Ualena Option Follow-Up Responses to FTA Comments

Figure 5-8 Ko'olohi Lagoon Beach Park—Project and Features

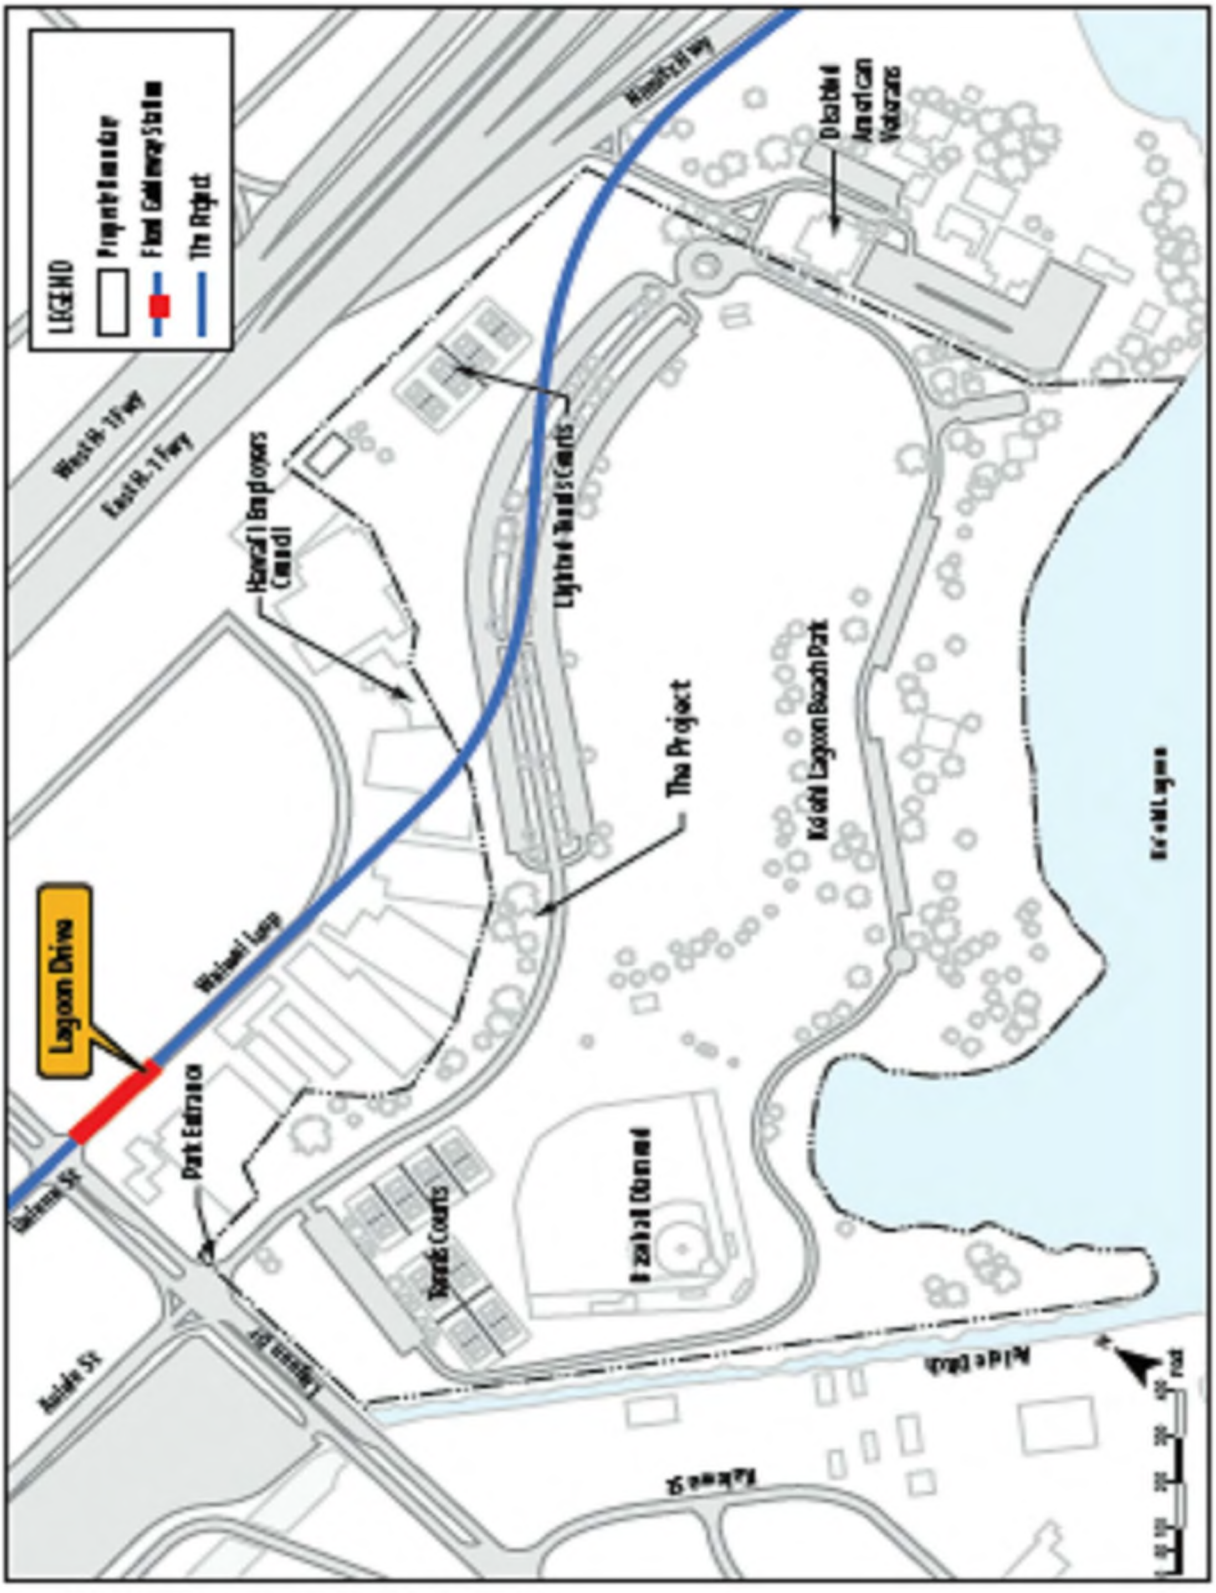
2. Describe how, in developing the avoidance alternative, efforts were made to minimize impacts on property acquisitions, privately owned businesses, historic properties, and Keehi Lagoon Beach Park. We also note that the DEIS did not document the 4(f) effects at Keehi Lagoon Park as de minimis. FTA has yet to make a section 4(f) finding and we will need additional information to assist us in our finding.

Ke`ehi Lagoon Beach Park (De minimis Impact)
Description and Significance of Property
Ke`ehi Lagoon Beach Park is an approximately 70-acre community park at Lagoon Drive and Aolele Street (Figures 5-7 and 5-8). It is bounded on the makai side by Ke`ehi Lagoon and on the mauka side by mixed industrial developments and Nimitz Highway, which at that point is on a viaduct 10 feet above the park just outside its mauka border. The park is Koko Head of Lagoon Drive and `Ewa of the Disabled American Veterans Ke'ehi Lagoon Memorial. It is operated and maintained by the DPR. There are two parking areas—the smaller one (53 spaces) is near the lagoon, and the larger one (421 spaces) is adjacent to the park's access road near the mauka border of the park. The recreational use of the park is primarily for daytime activity, with limited use of four lighted tennis courts in the evening.

All of the recreational features, attributes, and activities of the park, other than the four lighted mauka tennis courts, are located makai and away from the Project. The Project will traverse the park near its mauka property line, generally following the alignment of the park's access road until it leaves the park, where it continues on an elevated guideway within the right-of-way of Nimitz Highway. In the park, the Project guideway will be approximately 30 feet wide, between 30 to 35 feet high, and will be elevated above approximately 1 acre of land within the park, primarily in the parking lot and the park access road. Within the park, the guideway will be constructed on approximately 10 columns that will be about 6 feet in diameter, which will result in the use of approximately 280 square feet of park land for the placement of columns.

Measures to minimize harm were considered in the Project's design in coordination with the DPR. To minimize project use of the park, the project guideway was designed as close to the mauka boundary as possible, consistent with operational and engineering constraints, and to be away from the recreational activities and facilities, including the baseball diamond, open field, paved walking path, picnic areas, pavilion, and access to the water where canoeing events occur and most of the tennis courts are located. The views of the water by park users will not change with the Project. Looking mauka, near the water, the Project will be slightly more visible than the H-1 Freeway in the background and will not noticeably change the character of the landscape (Figure 4-27 in Chapter 4 of this Final EIS).

The Project guideway was designed with the minimal curve radius needed to maintain efficient system operation to serve the Lagoon Drive Station, while minimizing impacts to the park. The support columns have been designed to use as little park land as practicable, be located in areas away from recreational activities, and accommodate access to the park by recreational users. The alignment is designed to be elevated above the parking area, and there will be no net loss of parking spaces.

None of the 12 tennis courts will be permanently used by the Project. The guideway will cross above the park, just makai of the four lighted mauka tennis courts near Nimitz Highway, as shown in Figure 5-8. Given their proximity to the guideway, these tennis courts will be closed during construction and reopened as unlighted tennis courts when this portion of the Project is completed. DPR's desire is to have lighted tennis courts available for evening use. To accomplish this and mitigate temporary impacts to these lighted mauka tennis courts, RTD will coordinate with DPR during Final Design to provide lighting and associated resurfacing for four of the tennis courts near the park entrance prior to construction so that nighttime tennis court use will be maintained during construction and after project completion. The lighting will be designed and constructed in accordance with regulatory requirements.
